DEVELOPMENT REVIEW COMMITTEE (DRC) COMMENT REPORT

PROJECT NAME: Boathouse Restaurant Signage

CASE NUMBER: R18041

REQUEST: Site Plan Level II Review: Regional Activity Center Sign

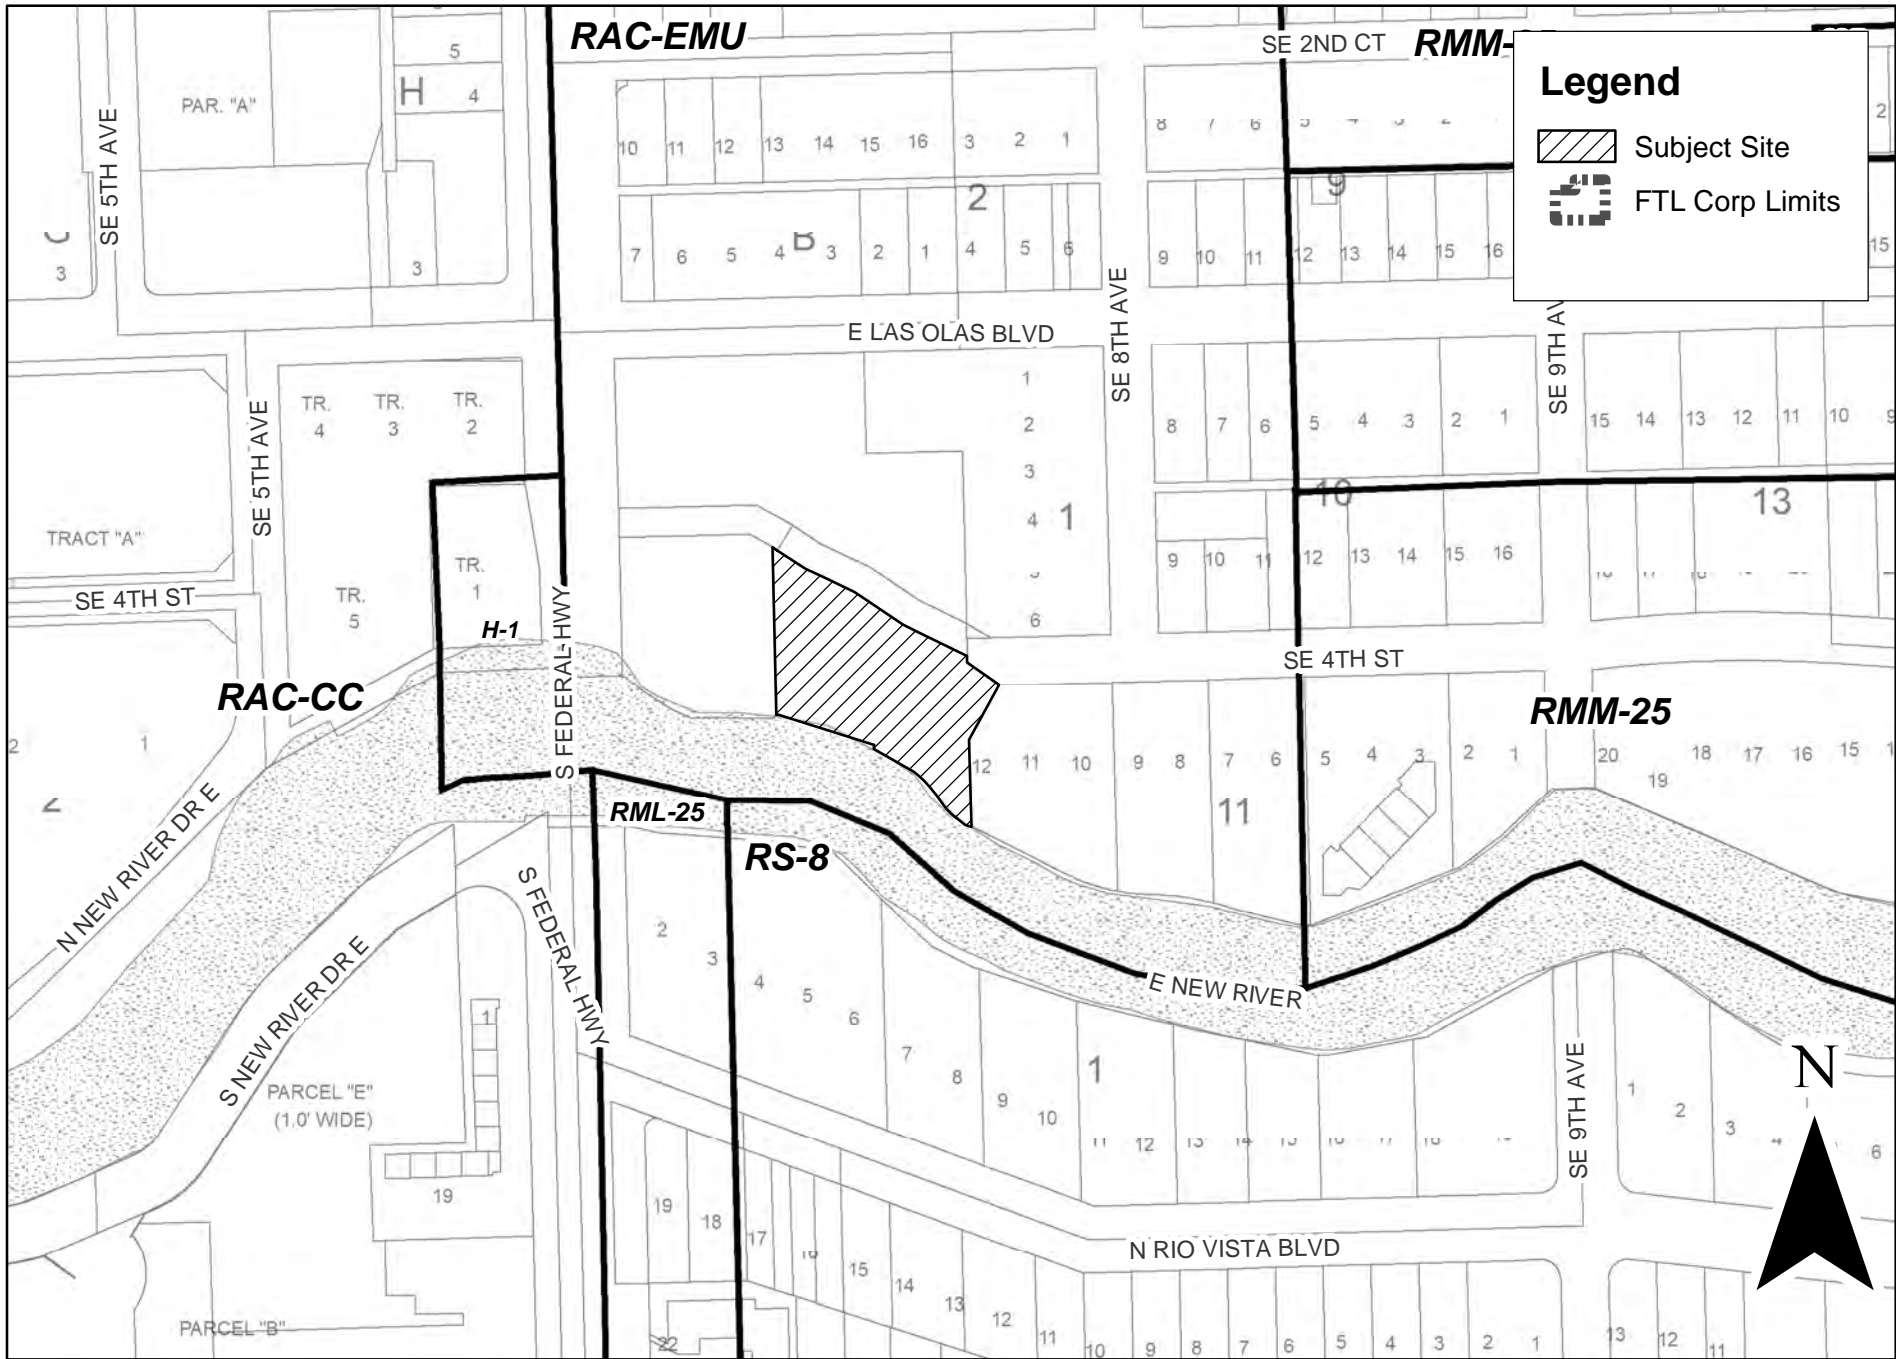
- 5) Due to the proximity of nearby residences along the riverway, backlit signage is highly discouraged and the use of full cutoff gooseneck lighting fixtures is a preferable illumination alternative. Moreover, to decrease the effects of lighting along the riverway, signage lighting should be turned off after operating hours.
